DRAFT FINAL DECISION DOCUMENT
FOR THE INTERIM RESPONSE ACTION
AT THE
MOTOR POOL AREA
ROCKY MOUNTAIN ARSENAL
FEBRUARY 1990
CONTRACT NO. DAAA15-88-D-0022/0002
VERSION 3.1

RESPONSE TO EPA'S COMMENTS
ON THE PROPOSED DECISION DOCUMENT
FOR THE INTERIM RESPONSE ACTION
AT THE MOTOR POOL AREA, VERSION 2.0
NOVEMBER 1989

RESPONSE TO SHELL OIL'S COMMENTS
ON THE PROPOSED DECISION DOCUMENT
FOR THE INTERIM RESPONSE ACTION
AT THE MOTOR POOL AREA
VERSION 2.0, NOVEMBER 1989

RESPONSE TO STATE OF COLORADO'S COMMENTS
ON PROPOSED DECISION DOCUMENT
FOR OTHER CONTAMINATION SOURCES IRA
MOTOR POOL AREA

Figure 2-3

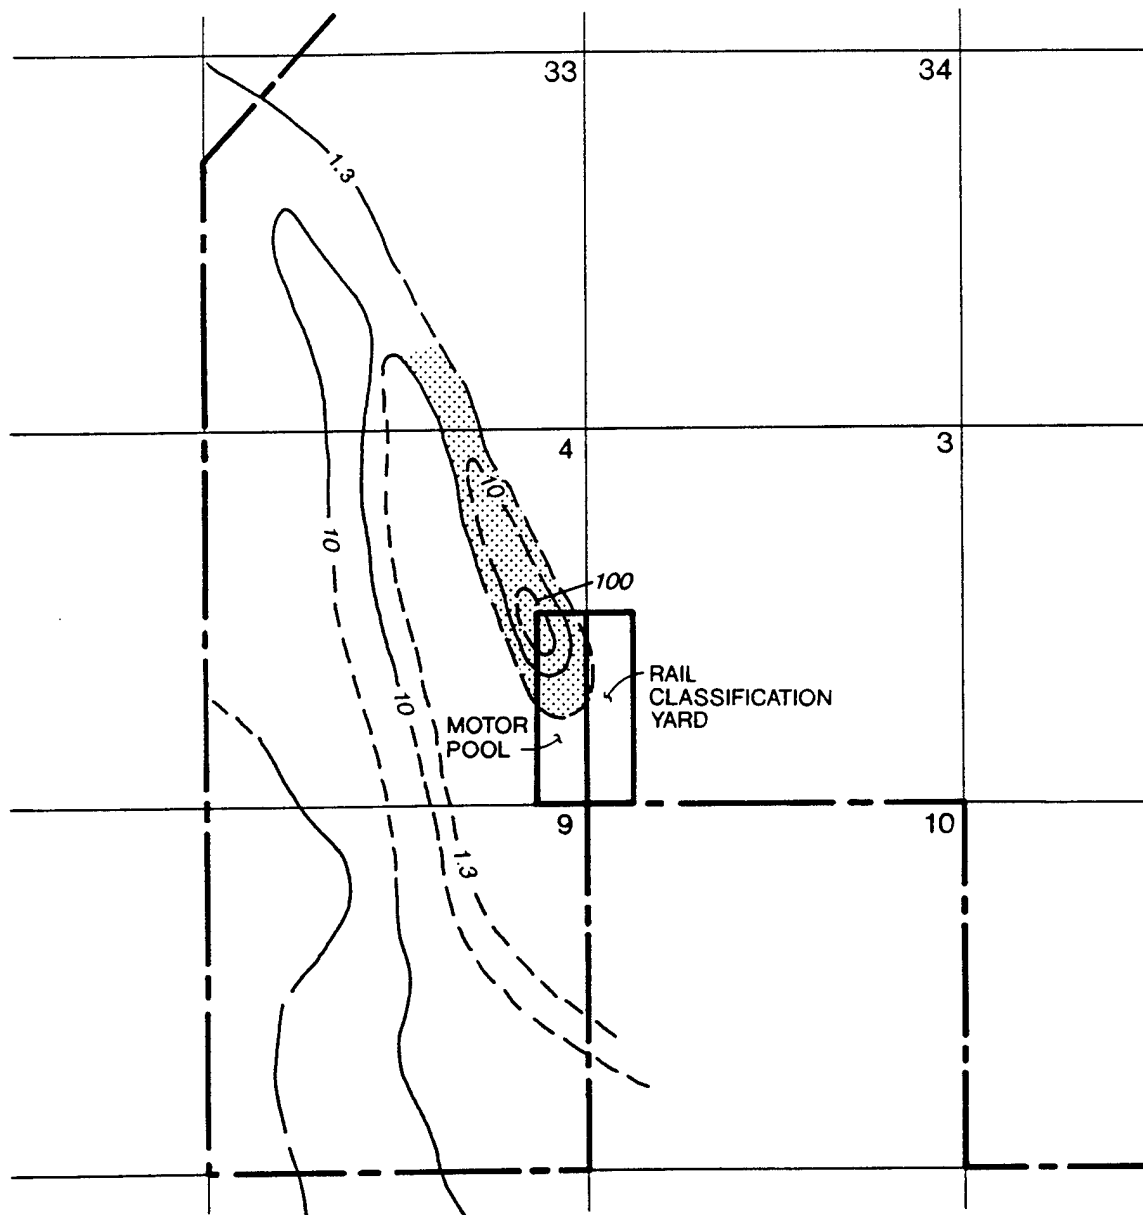
Comment 2: Units of concentration from the soil gas survey should be applied to the concentration lines on Figure 2-3.

Comment 7: In Figure 2-3, the soil gas concentration contours do have units. If the units are ug/l gas, then there appears to be an approximate order of magnitude discrepancy between values reported in this study and the Ebasco investigation (see Figures 2-17, results of field and laboratory investigations conducted for the remediation of other contamination sources).

Response: The figure has been revised.

Response: Soil gas is a fairly qualitative method of identifying possible sources of contamination. Both investigations indicate a contamination source in the same vicinity. However, soil contamination concentrations cannot be quantitatively inferred from soil gas results.
